# Wollongong Local Planning Panel Assessment Report | 7 December 2021

<b>WLPP No.</b>	<b>Item No. 3</b>
<b>DA No.</b>	DA-2021/103
<b>Proposal</b>	Designated Development - Residential - demolition of dwelling house and construction of new dwelling house and swimming pool
<b>Property</b>	603 Lawrence Hargrave Drive Wombarra Lot 16 DP 5998
<b>Applicant</b>	Gyles Deacon
<b>Responsible Team</b>	Development Assessment and Certification - City Wide Team (KR)

## ADDENDUM REPORT

B85 SWEEP PATH - RIGHT SIDE FORWARD ENTRY  
SCALE 1:200

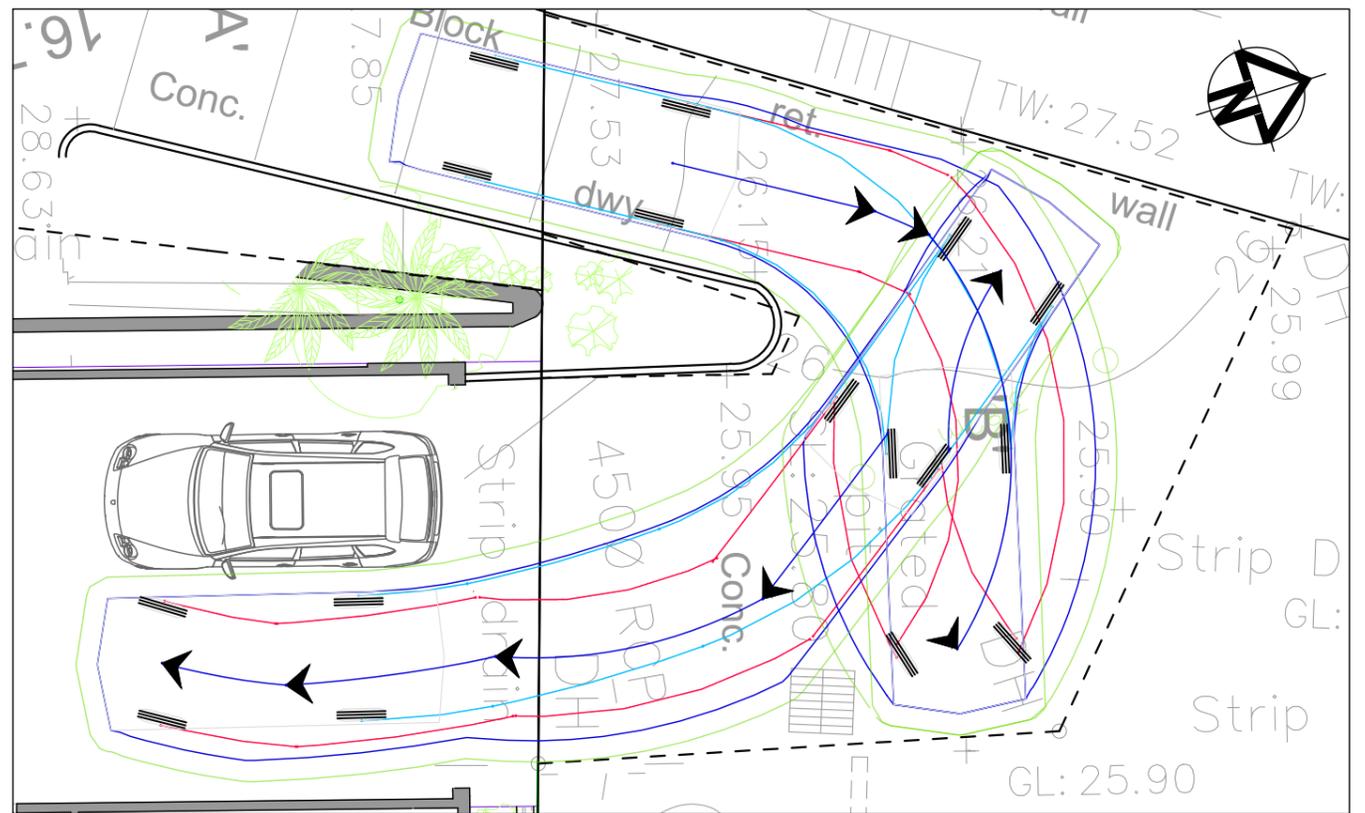
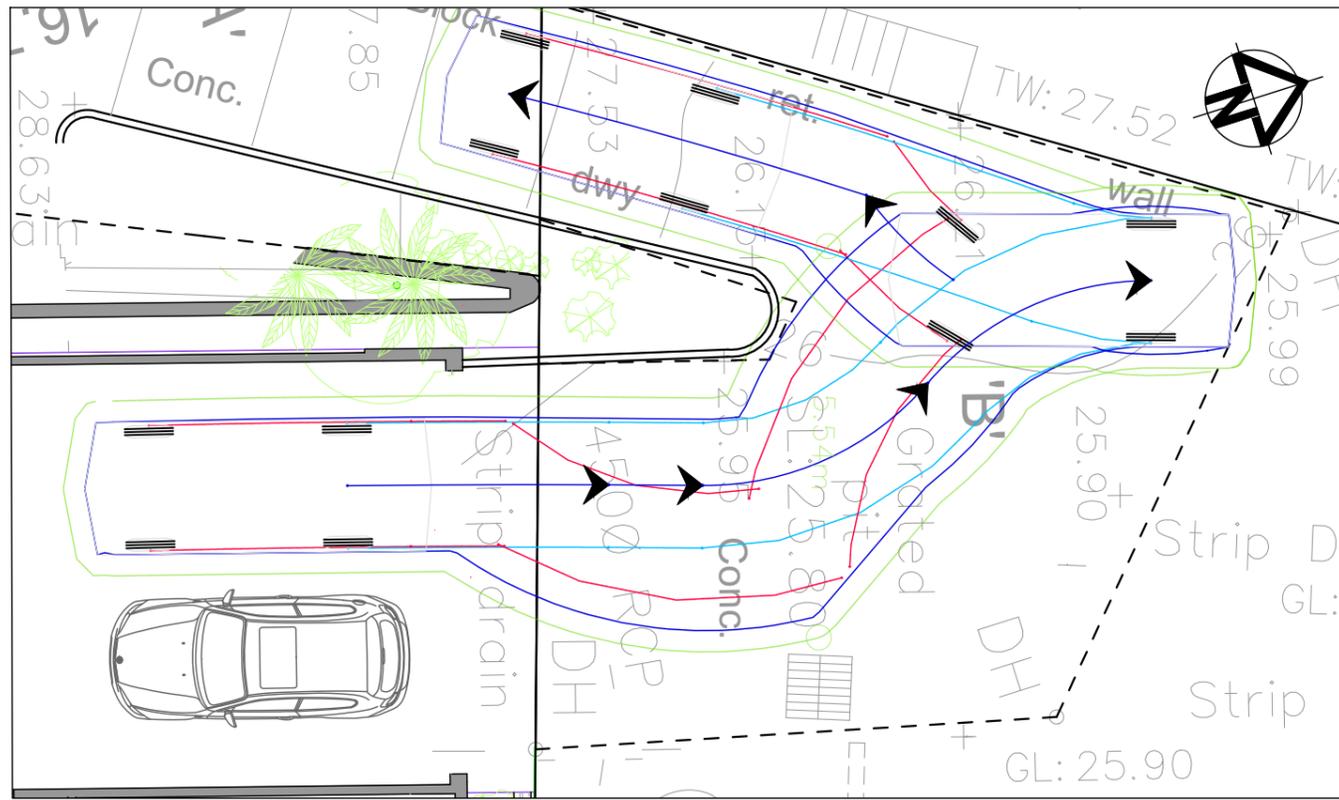
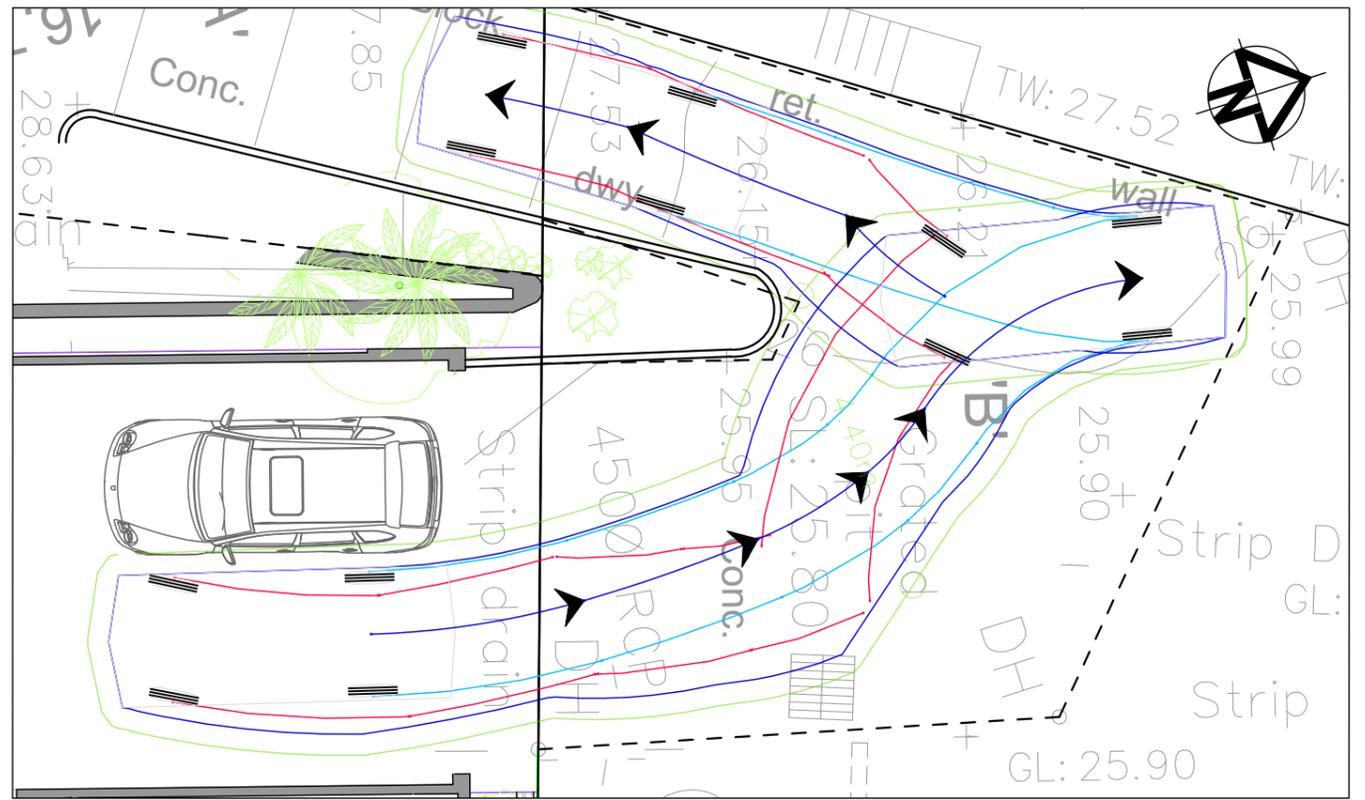
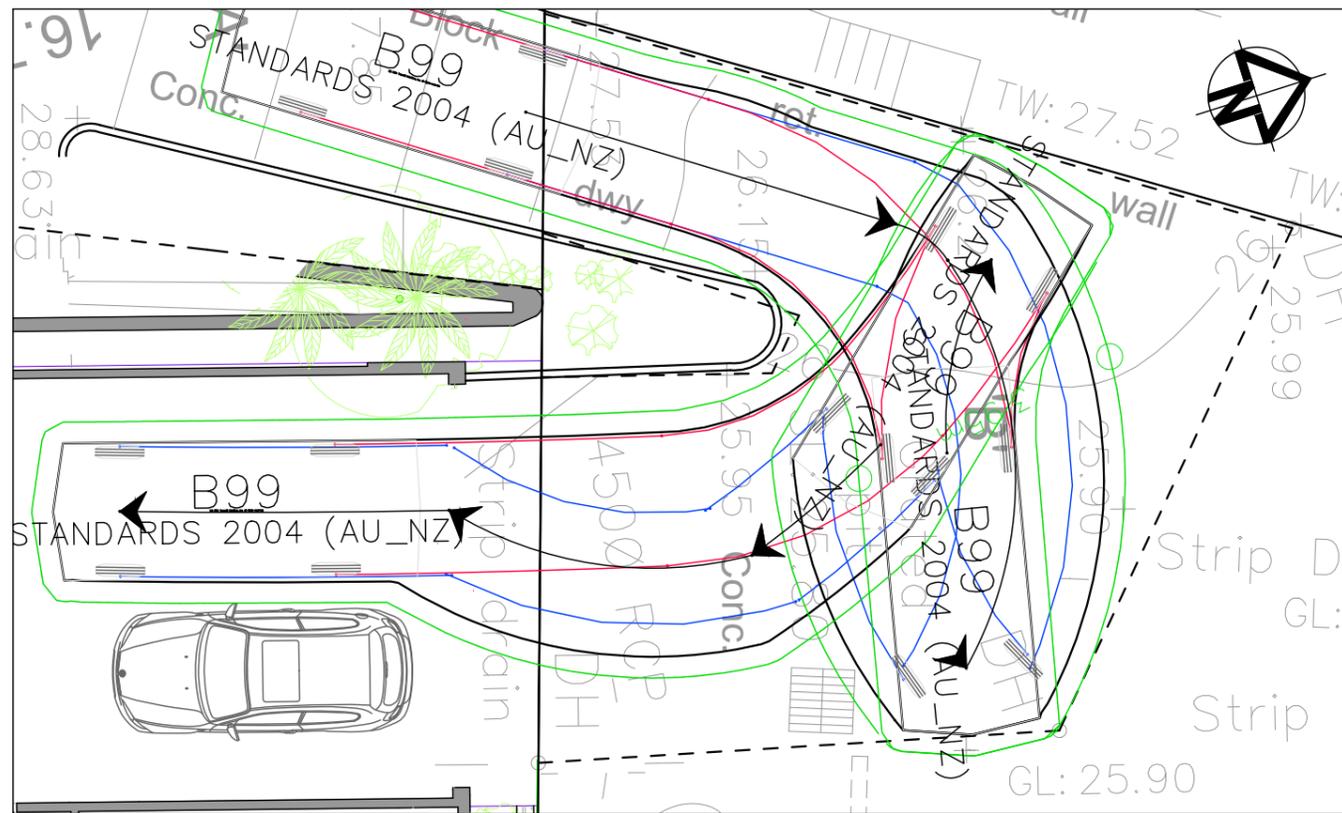
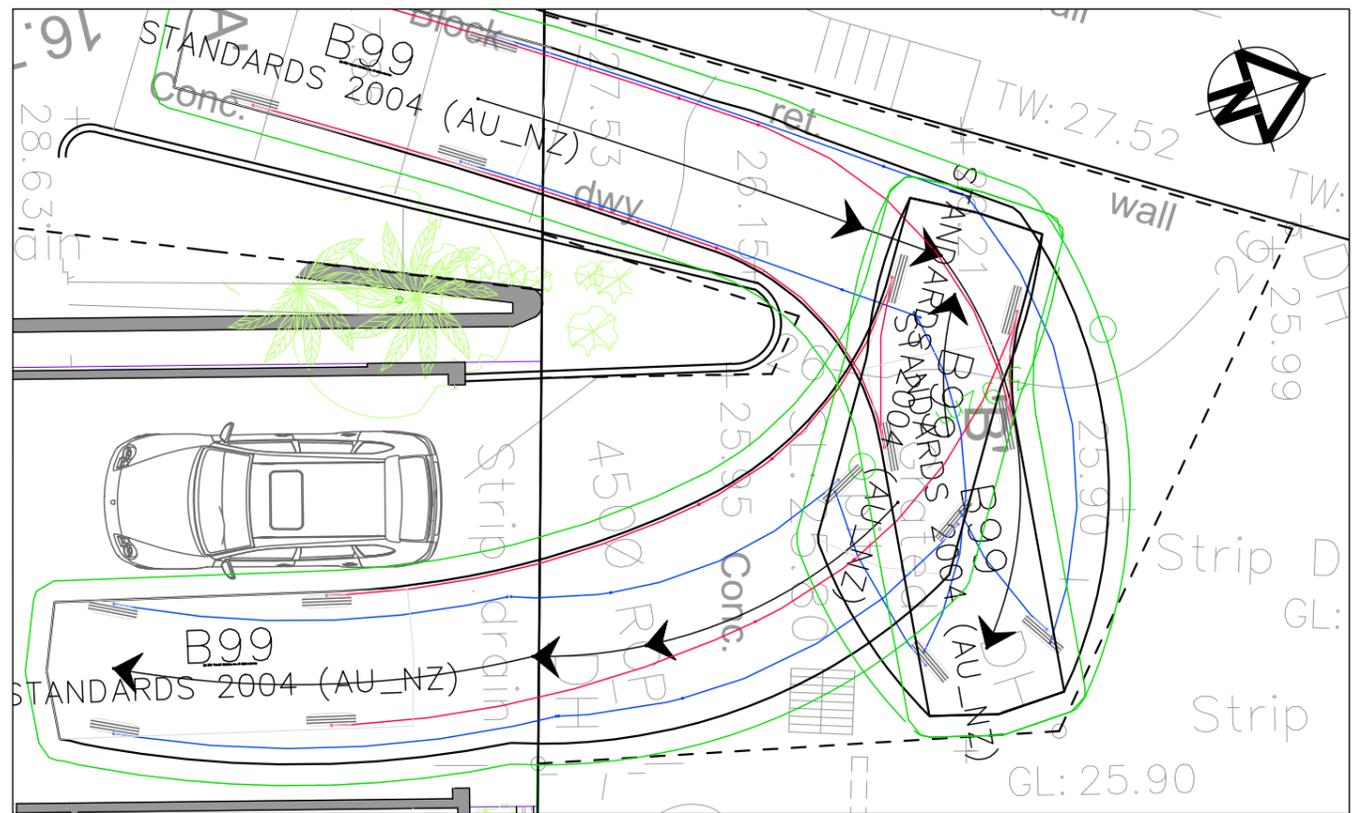
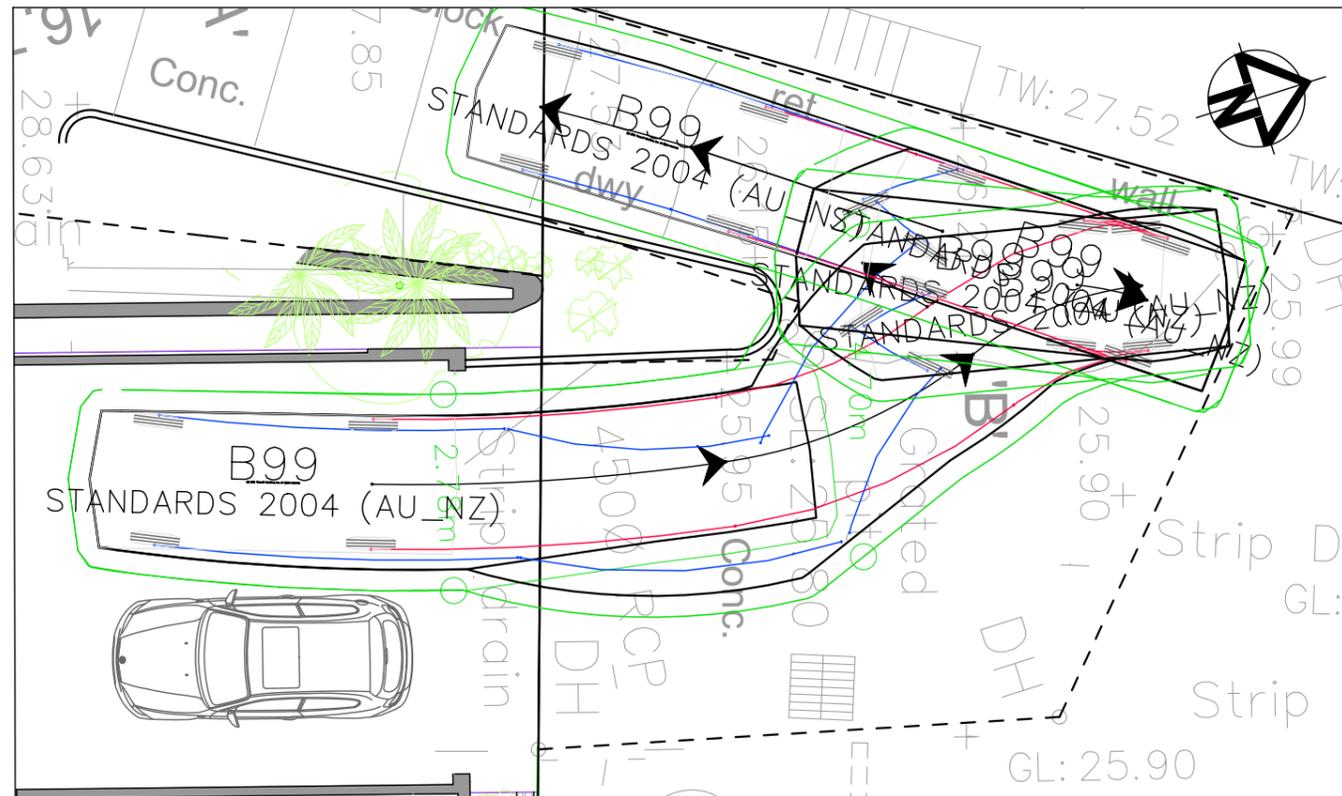
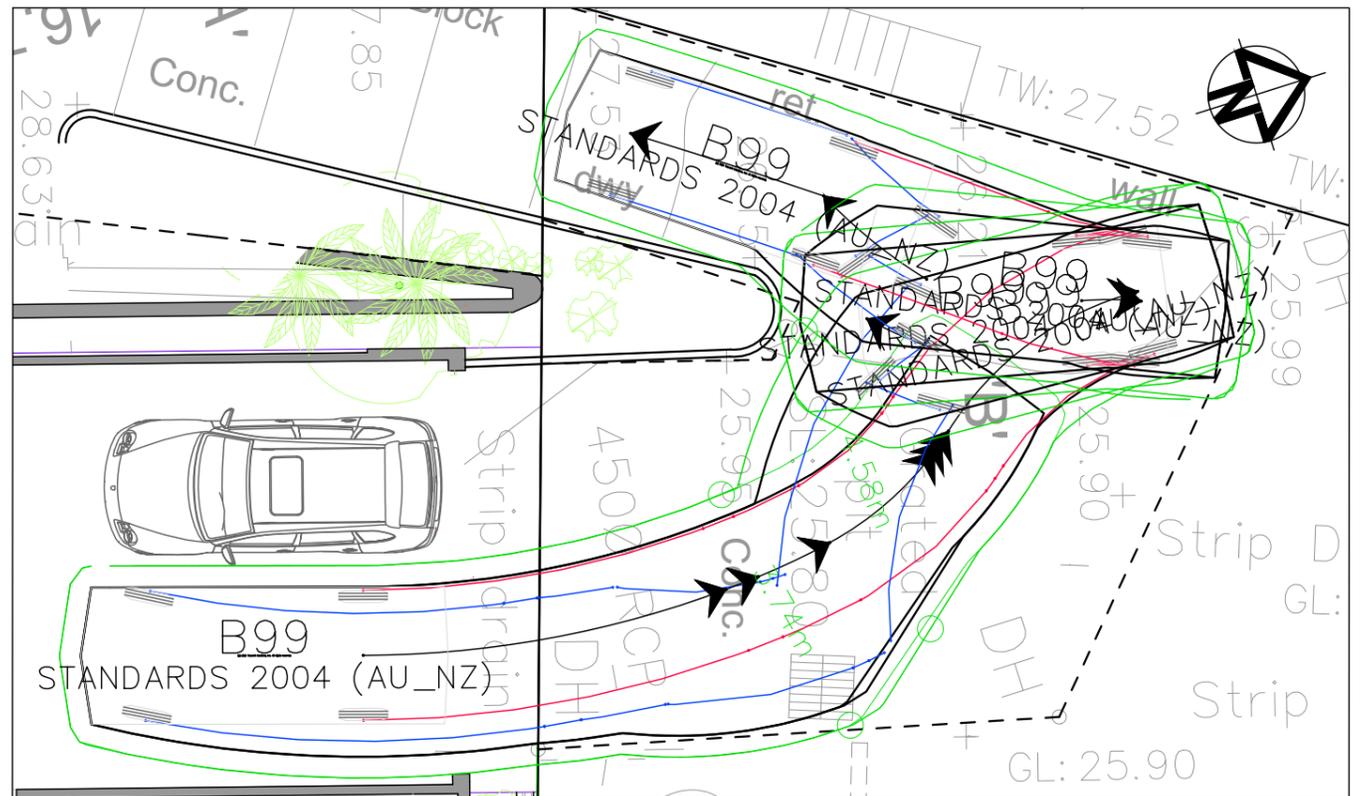
- *The applicant is to provide a swept path analysis demonstrating vehicular manoeuvring into and out of the proposed double garage can be achieved within the confines of the existing easement.*

A swept path analysis, prepared by SitePlus, has been submitted which demonstrates both a B85 and B99 vehicle can manoeuvre and enter and exit a forward direction within the bounds of the existing easement.

Council’s Traffic Officer has reviewed the swept paths and confirmed that the swept path analysis has been carried out as per the relevant traffic engineering guidelines, which show that the B99 vehicle

(largest anticipated vehicle in the Australian Fleet) can manoeuvre within the existing access easement without encroaching/impacting on neighbouring properties.
